5-6-2021

This letter is a follow up letter to the one we previously sent on April 2, 2001 regarding the revised 5-Lot subdivision on Canyon Creek S.

ATTACHMENT: Revised Lot Plans

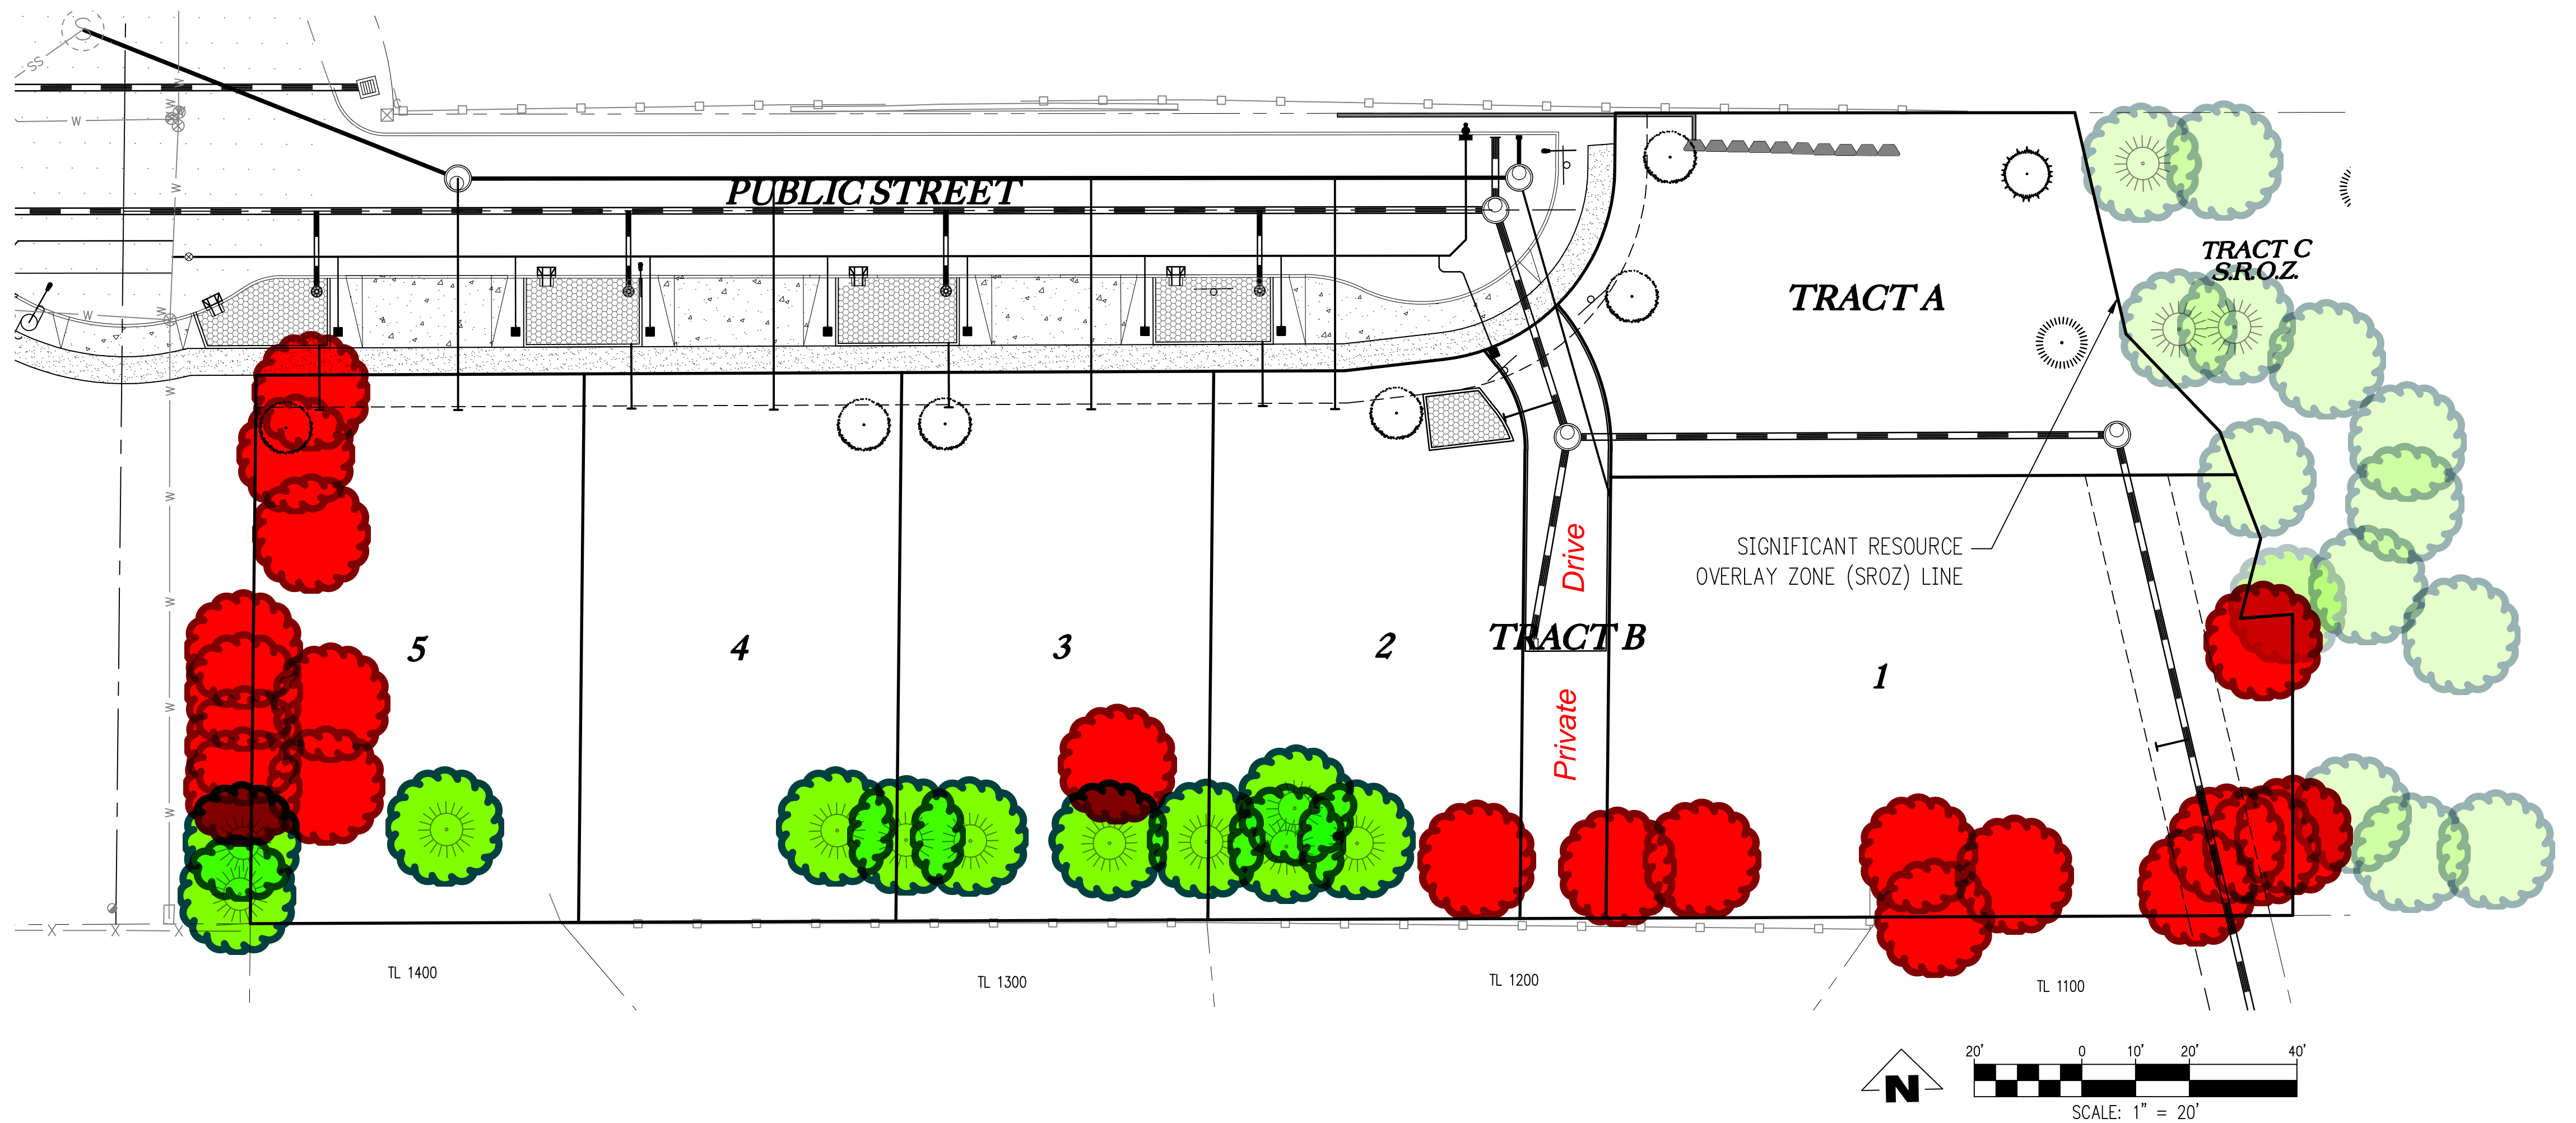
If the open space Tract A and Lot 1 were to swap places, there would be no need for the private drive to provide access to Lot 1. Access would be provided directly off the end of the street, similar to the previous plan for Lot 1 of 8. Access to the open space could be provided through a 15-foot easement along the western edge of Lot 1. This easement could be a pervious path surface and also double as the stormwater easement, allowing access for City maintenance. The stormwater pipes could be routed south from the main street through the side of Lot 1, then along the north edge of the open space. This would also avoid Lot 1 having the utility run along the back of the property. It appears the pipes and manholes could be installed with plenty of room to protect the roots of the trees along the south side of the revised open space.

Attached are some sketches of the proposed development with Lot 1 and Tract A on opposite sides. Option A only modified Lot 1 and Tract A, removing the private drive and using an easement for open space access and stormwater. Option B adds the modifications to Lots 2-5 to provide a 20-foot setback along the side of Lot 5, as described above.

Existing Plan:

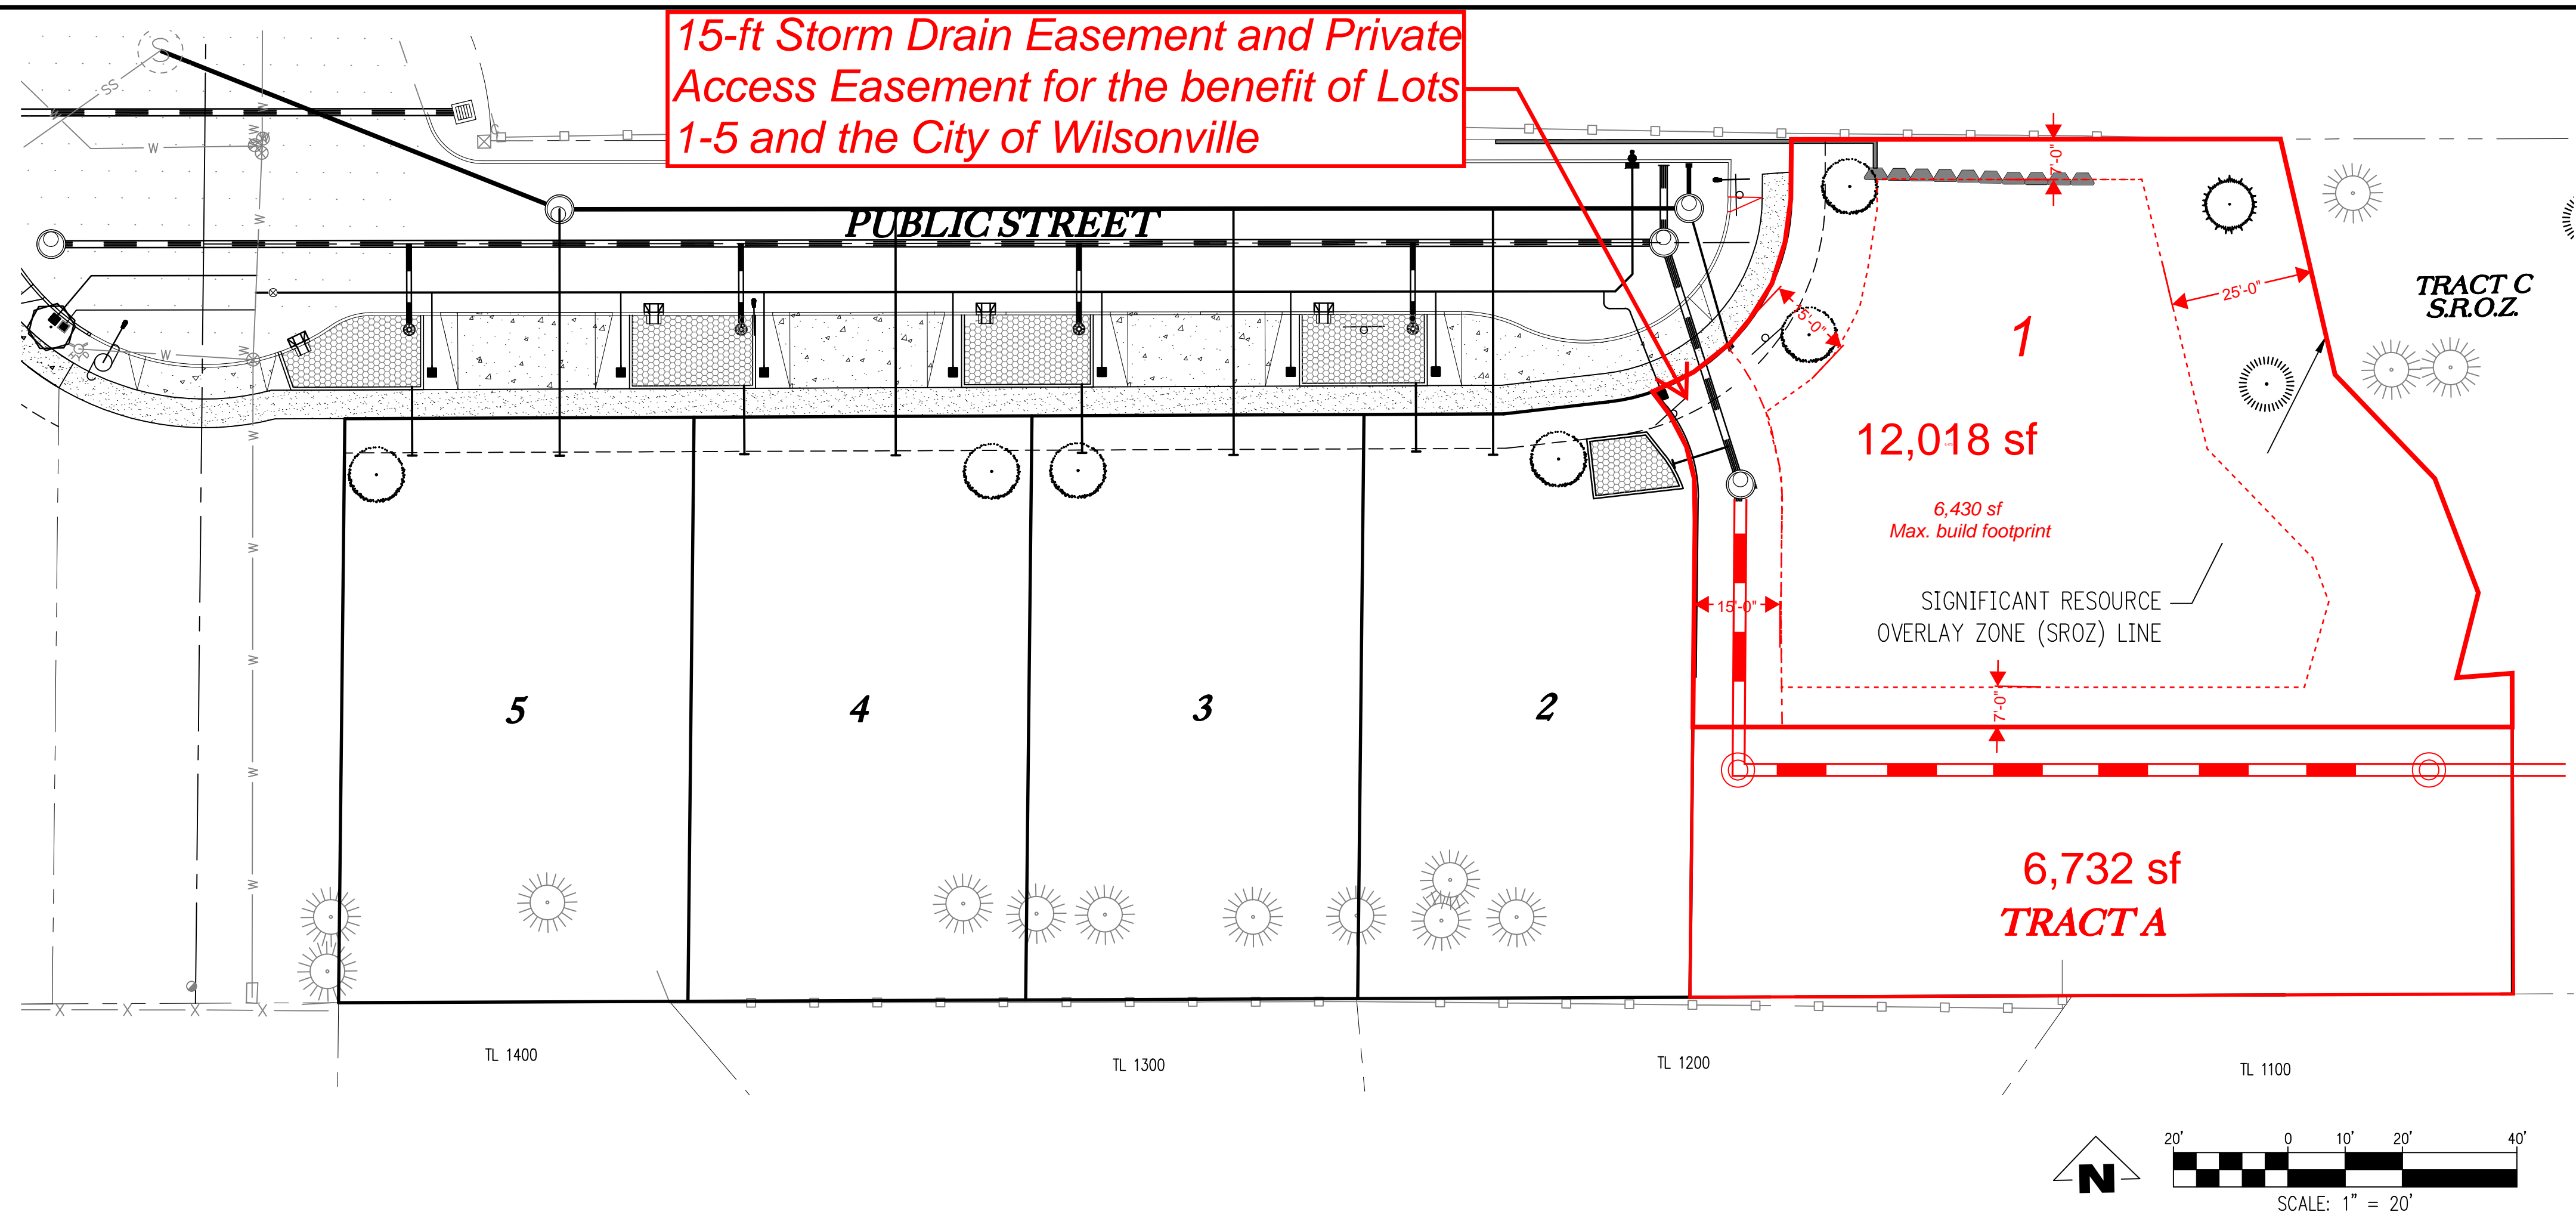
- Includes a private drive to access Lot 1
- Removes highest amount of trees
- Places Lot 1 house close to existing homes
- Includes utility easement through back of Lot 1
- Lot 1 is 10,200 sf, 5,090 sf max building footprint

Option A:

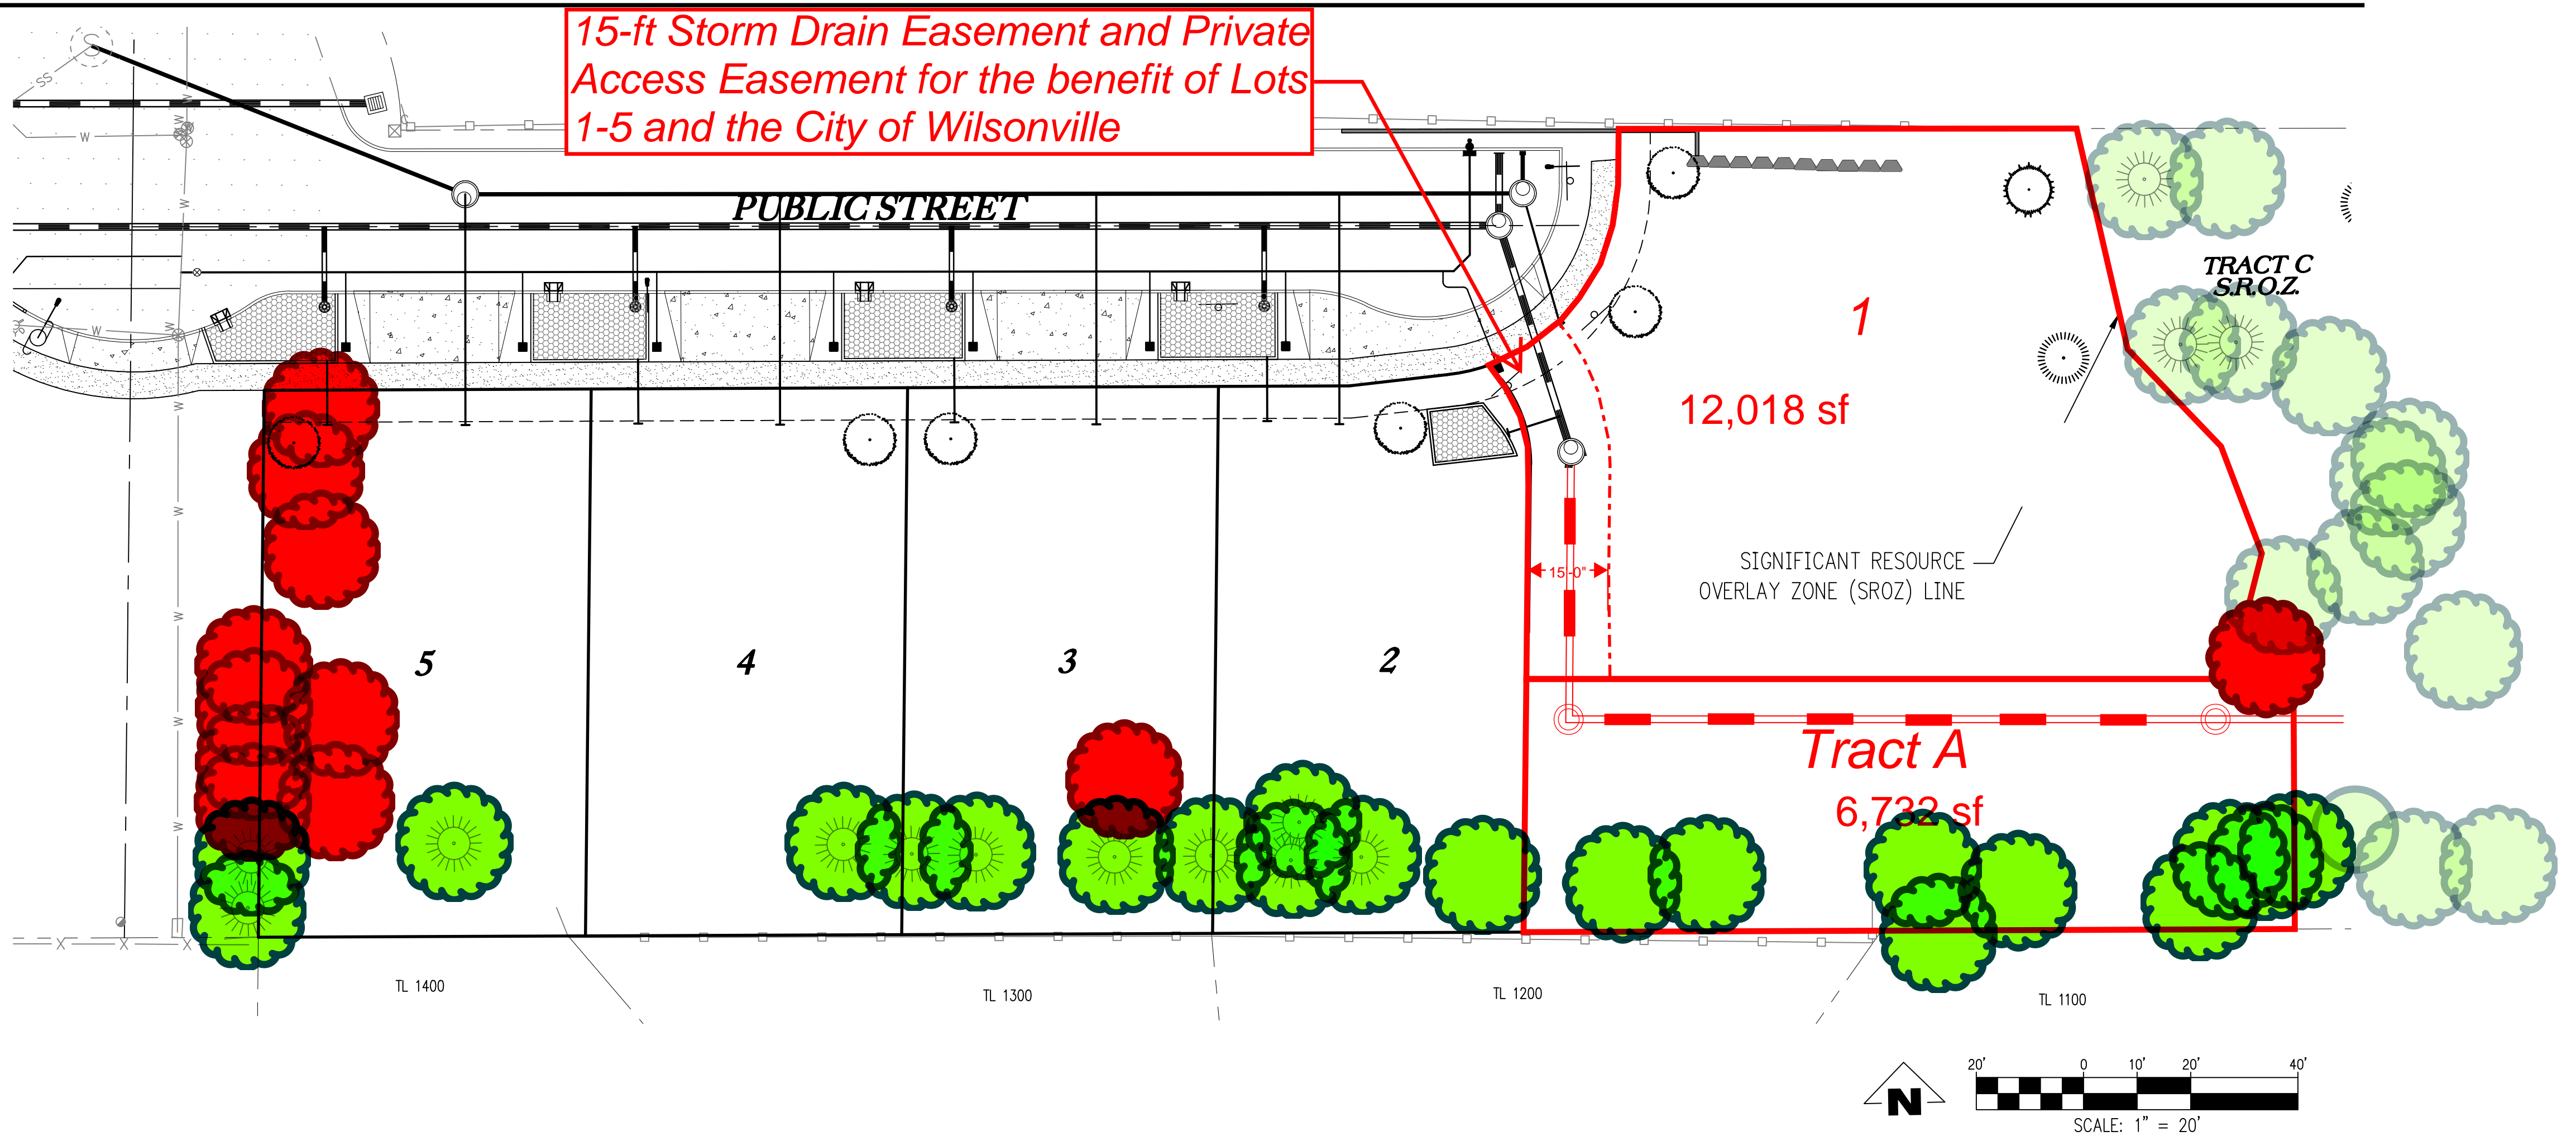
- Lots 2-5 unchanged
- Lot 1 is 12,000 sf, 6,400 sf max. building footprint
- Lot 1 has 15' easement through side
- Serves as utility and public access
- Tract A includes storm pipes
- No private drive, just unpaved path
- 10 additional trees saved
